RE: your e-mail dated February 28, 2008; Risco Ltd.
FCC ID:JE4RWRT433, ATCB005950

Reply to ATCB remarks for Wireless sirens

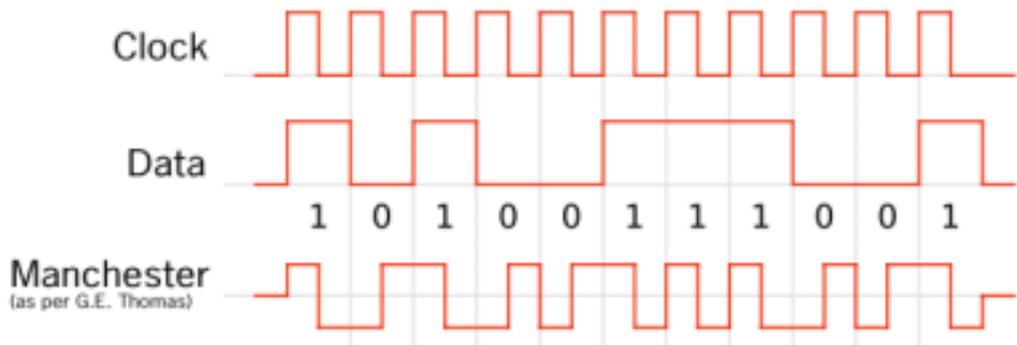
7. Normally operating transmitter sends the message to a control panel and receives the acknowledgment. Upon this the transmission associated with any single event like tamper, initialization, alarm or other is finished. The second and so on transmissions are associated with a lack of acknowledgment and mean that normal system operation is disturbed. In other words each of consecutive transmissions is triggered by lack of acknowledgment which cannot occur under the normal system operation.
8. The modulation used in the system is Manchester code. See below:

So a change of data ("1" after "0" or the opposite) cause the high and low periods to merge and the bitrate looks like half the actual bit rate (what you refer to as the big pulses). When there is a series of "1" or "0" then you get the actual bit rate (2.4KHz) which look like the small pulses. Either way the duty cycle of each pulse is 50% (ideally) and either way the count shall show the same duty cycle for worth 100ms:

Each pulse shall be 416µs, 50% of it shall be On time: 208us
 There are 140 pulses in a bursts, so total on time: 29.12
 So 29.12% duty is average factor of 10.7dB

However HL have measured the worst of all pulses, which is 0.48ms "On" time and 0.144ms "Off" time (duty cycle of 76.8% instead of 50% ideally) and calculated the average factor accordingly, so they got 6.7dB instead of 10.7dB.

We accepted this worst case calculation to avoid having to measure the length of each pulse and pulse, and the result is a worst case average factor.
